VILLAS AT ASPEN TRAILS PRELIMINARY PLAN

LOCATED IN SECTION 9,
TOWNSHIP 15S, RANGE 65W, OF THE 6TH P.M.,
EL PASO COUNTY, STATE OF COLORADO

SP-23-004

GENERAL NOTES

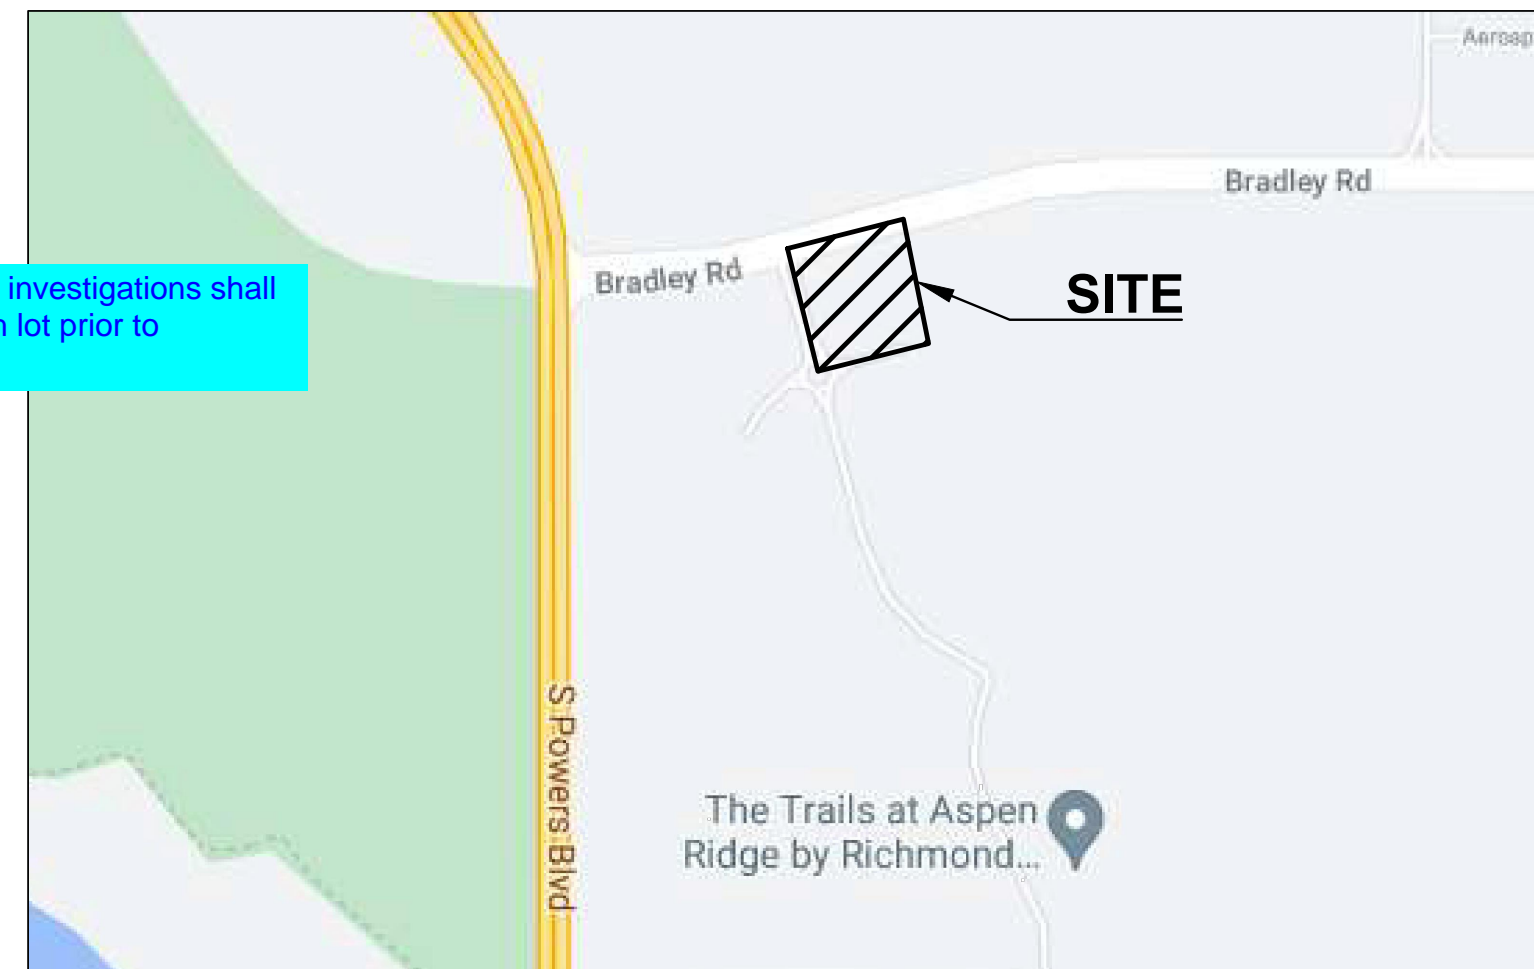
Missing lot easement note

list lots. Lot-specific investigations shall be required for each lot prior to construction.

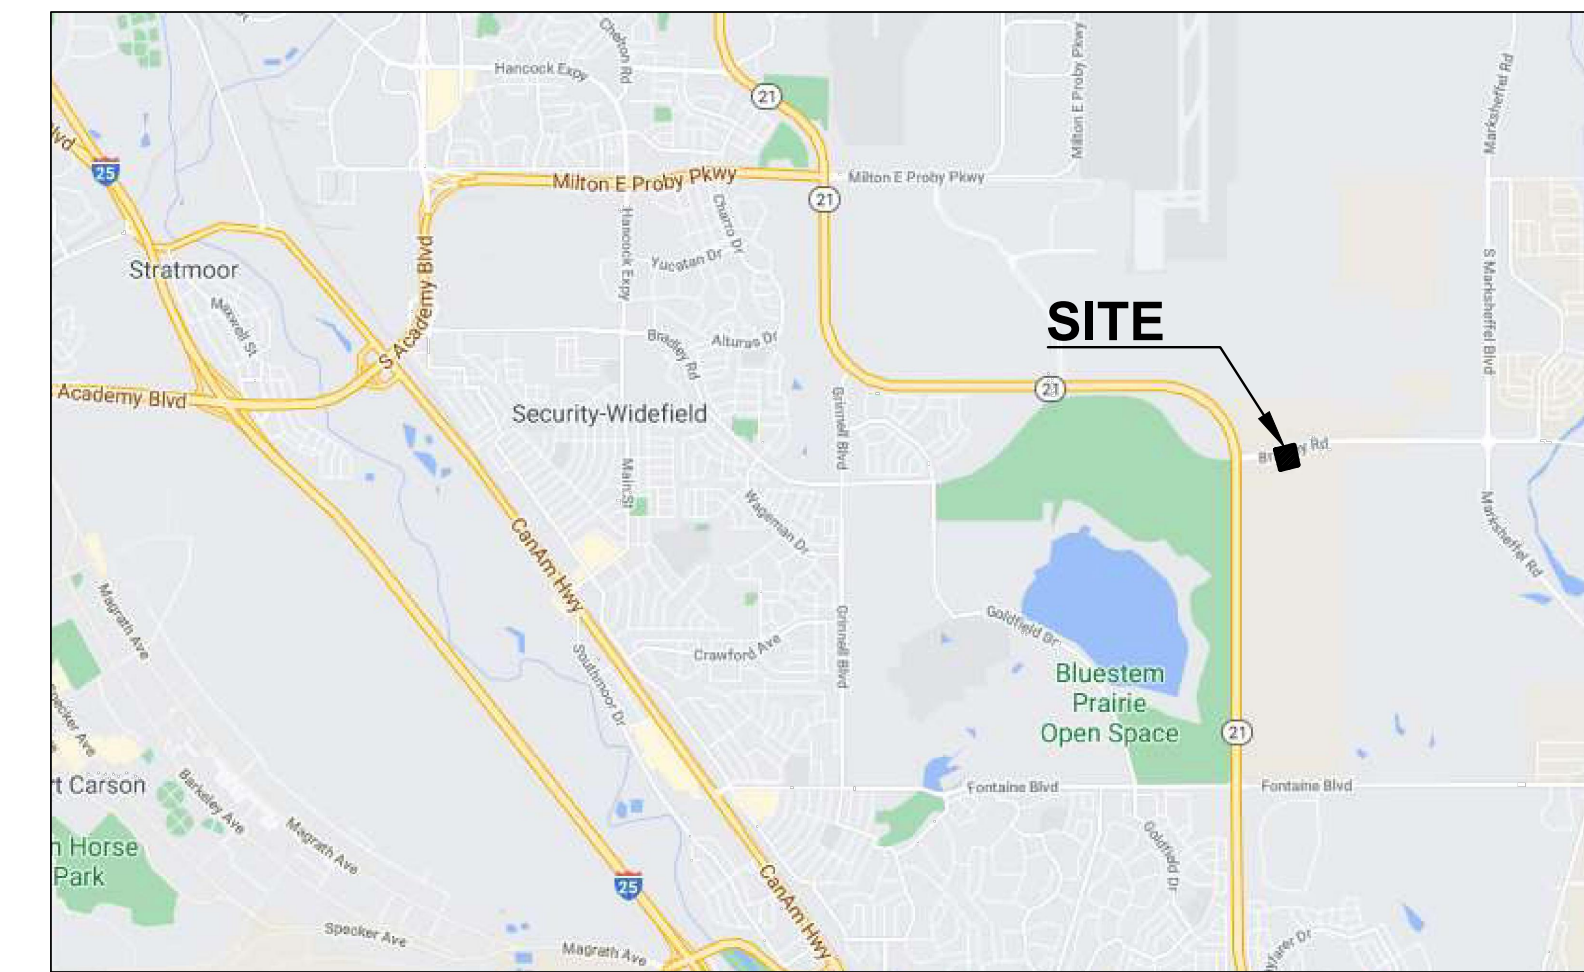
Add Note When the Property is Subject to Existing or Proposed Covenants:
All property within this subdivision is subject to a Declaration of Covenants as recorded at Reception No. _____ of the records of the El Paso County Clerk and Recorder.

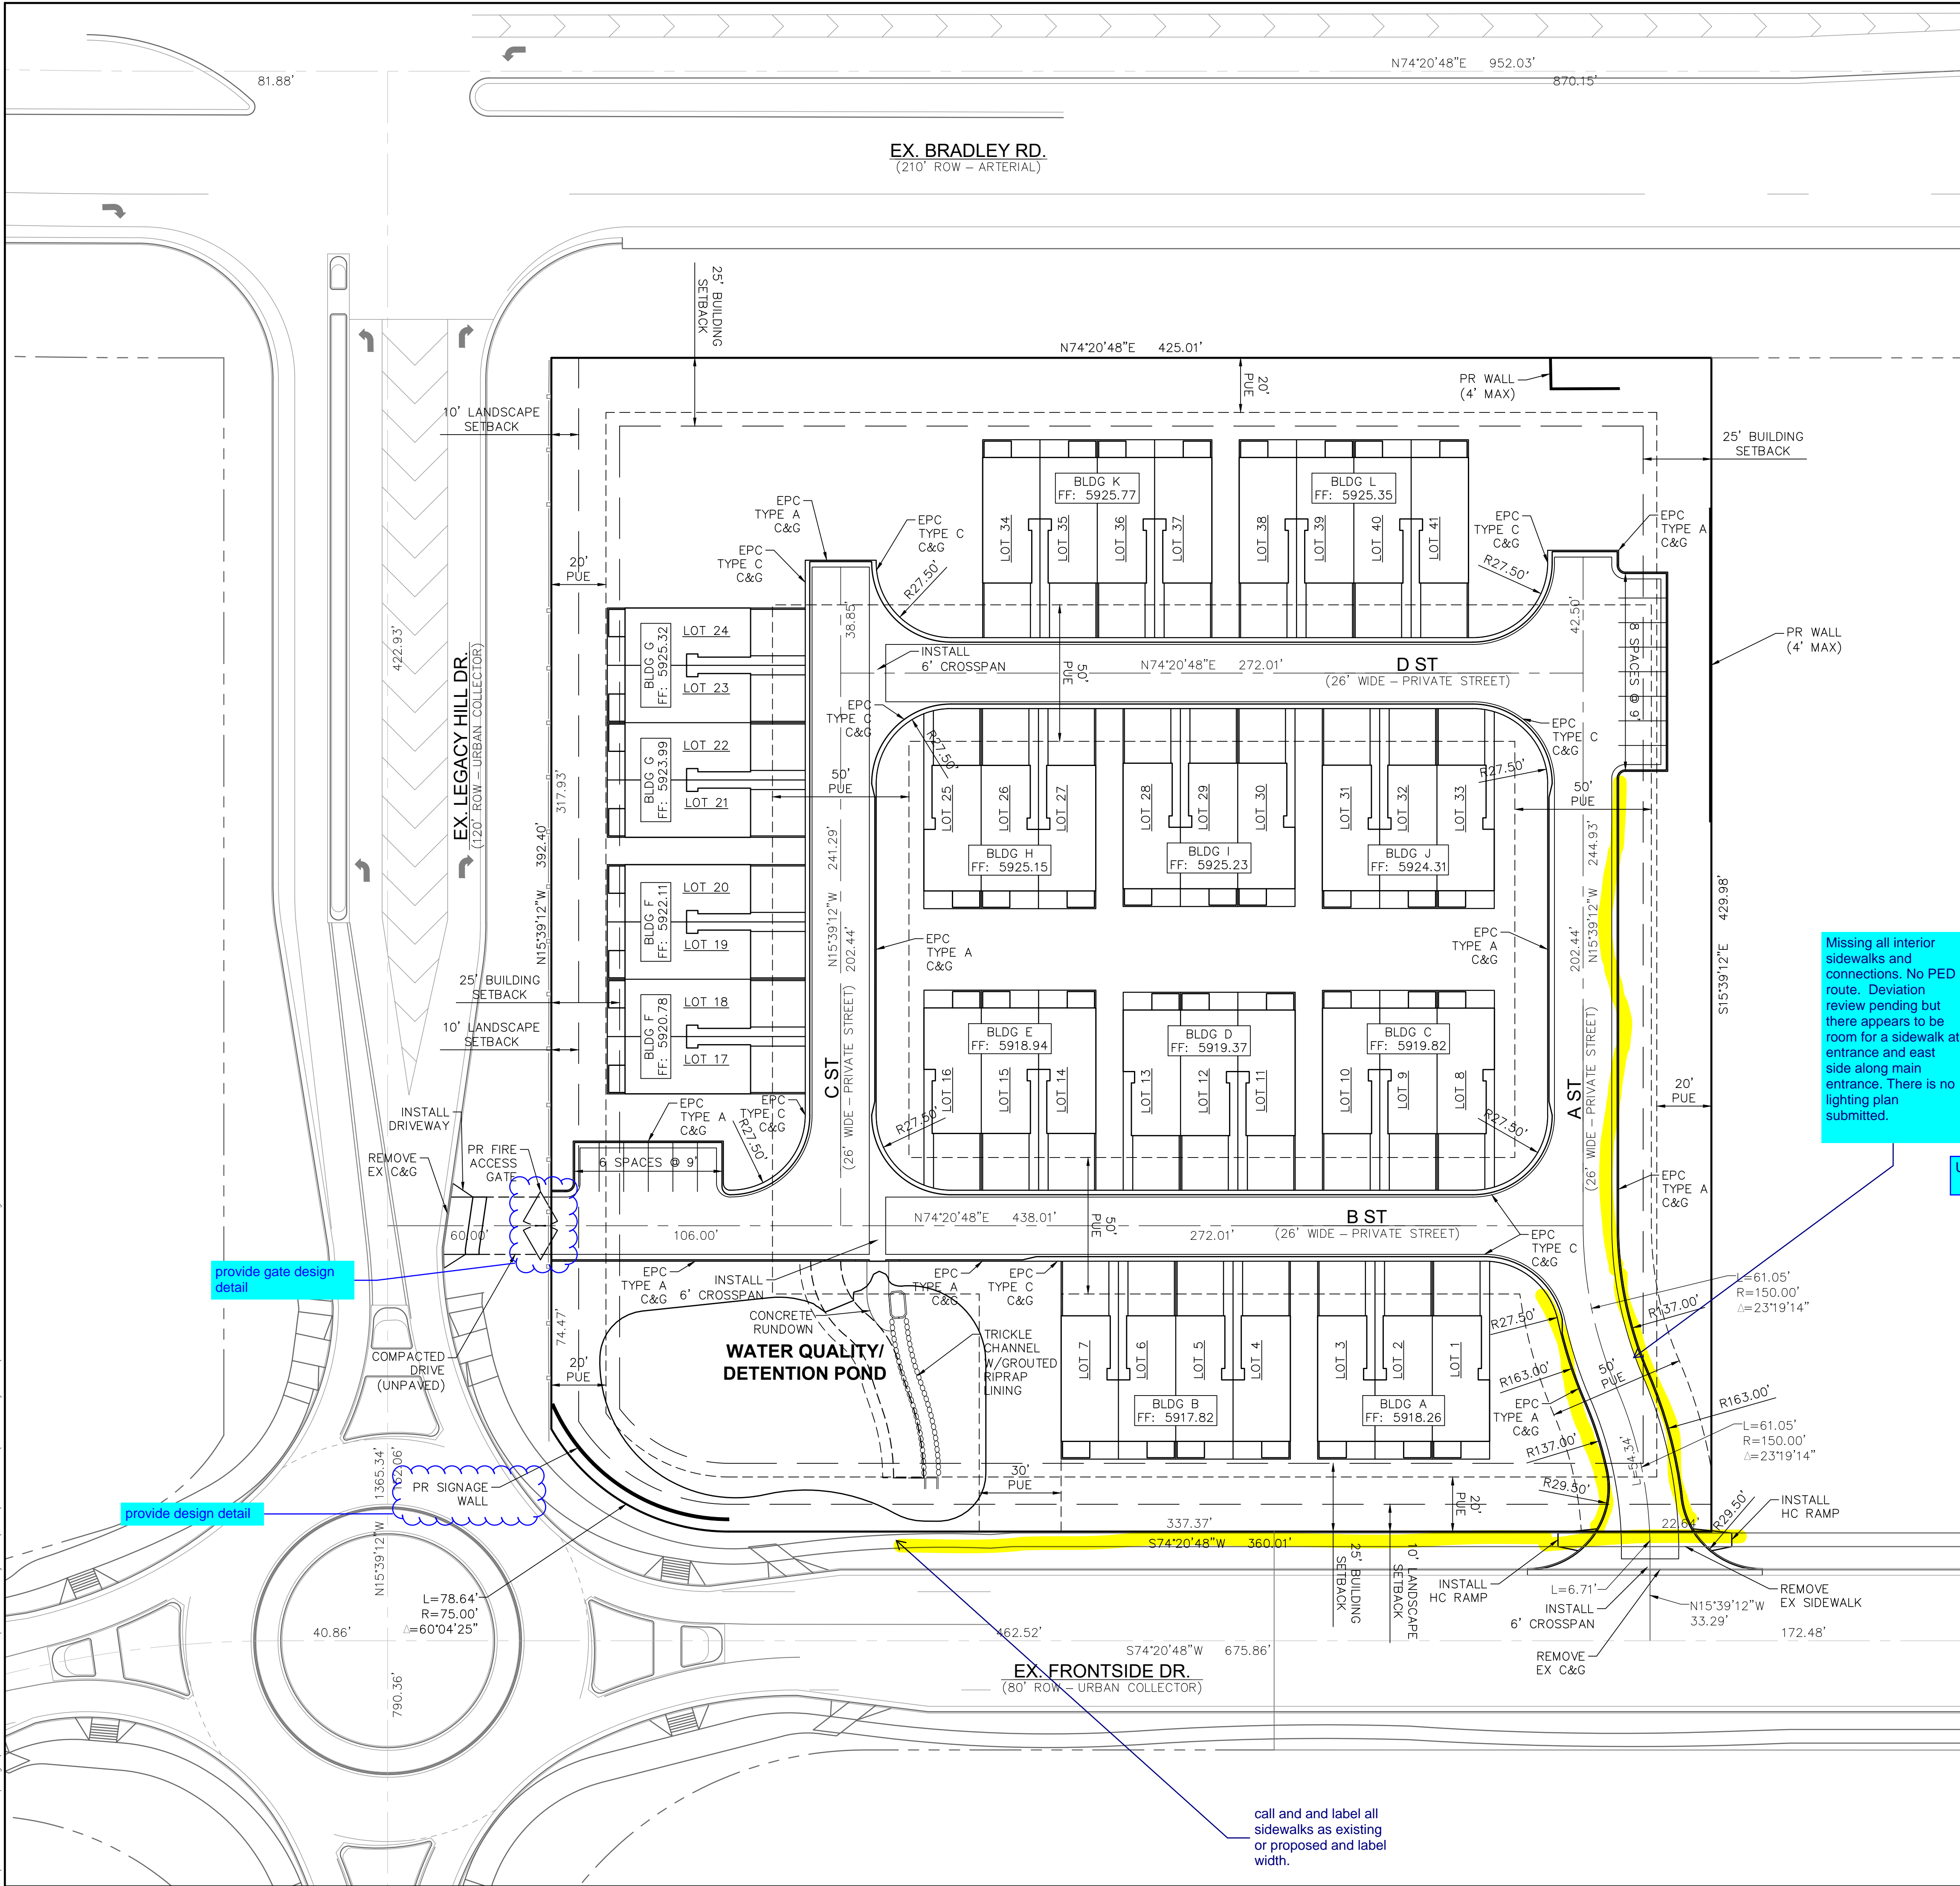
Missing all interior sidewalks and connections. No PED route. Deviation review pending but there appears to be room for a sidewalk at entrance and east side along main entrance. There is no lighting plan submitted.

Update street names

Add EPC Private Street sign design detail

provide gate design detail

provide design detail

call and label all sidewalks as existing or proposed and label width.

VILLAS AT ASPEN TRAILS
**PRELIMINARY PLAN
 UTILITY PLAN**

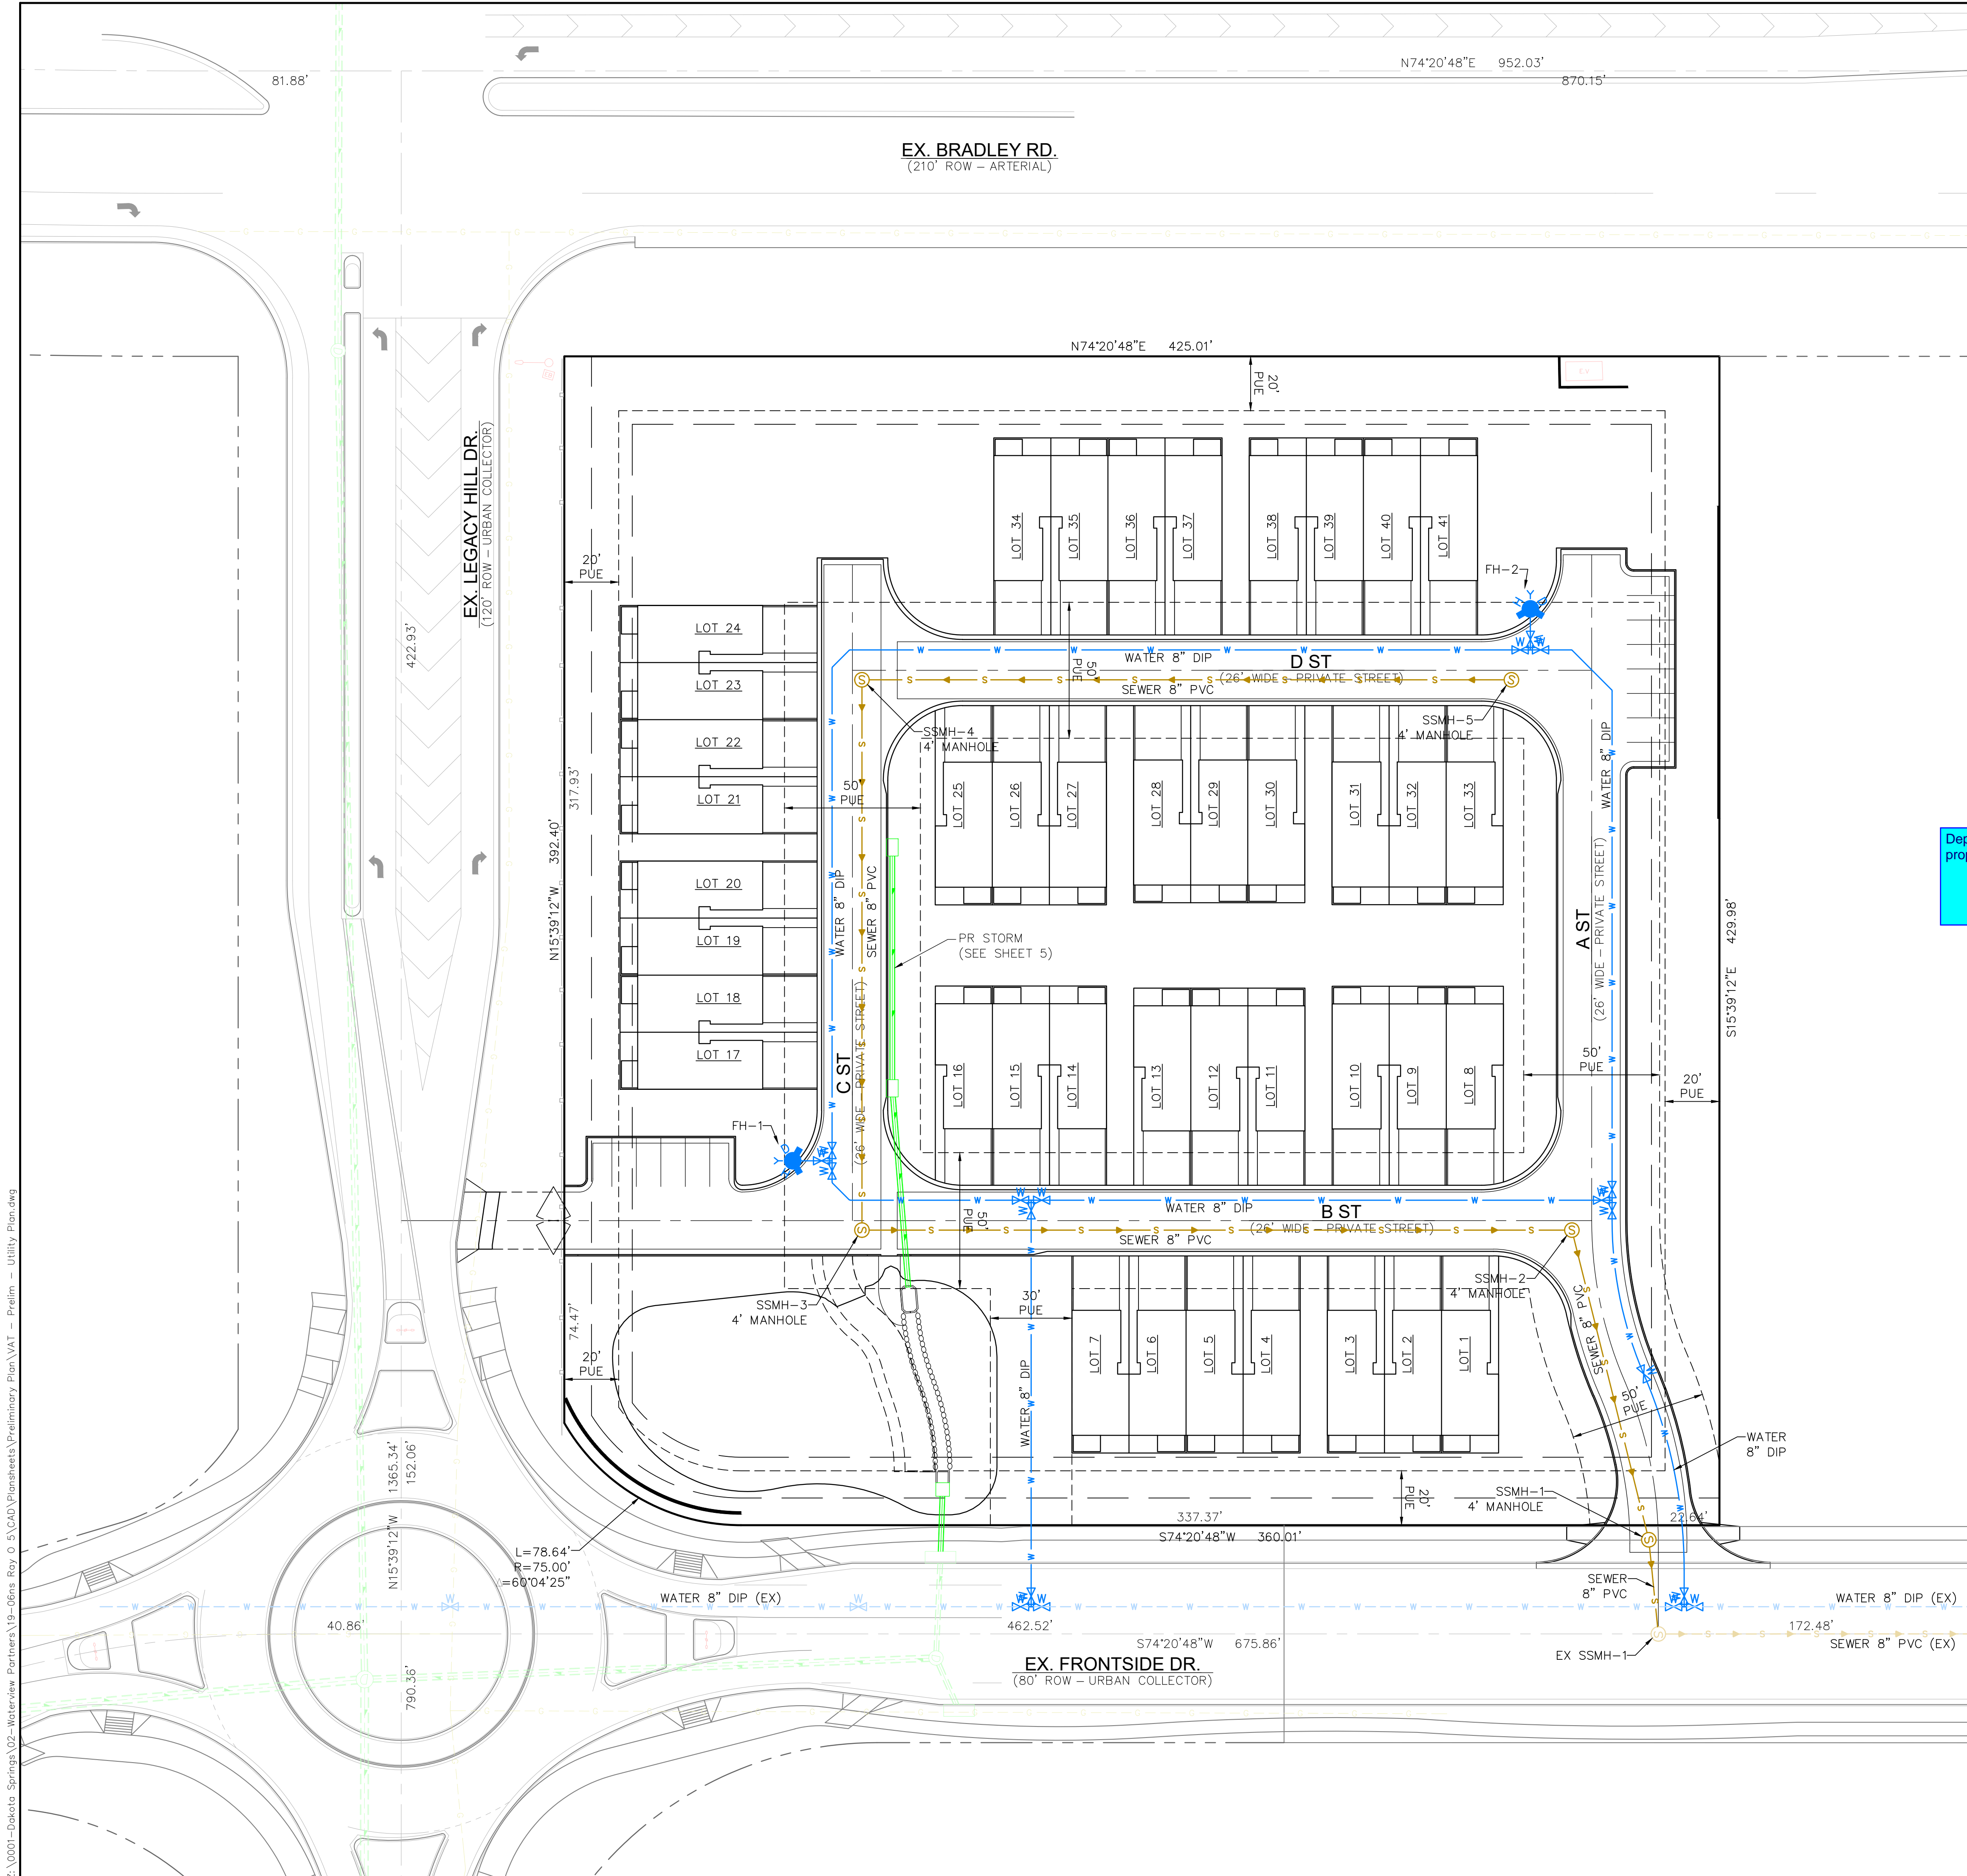
Add existing gas line to legend

Depict CSU gas line extension into property and main valve control location
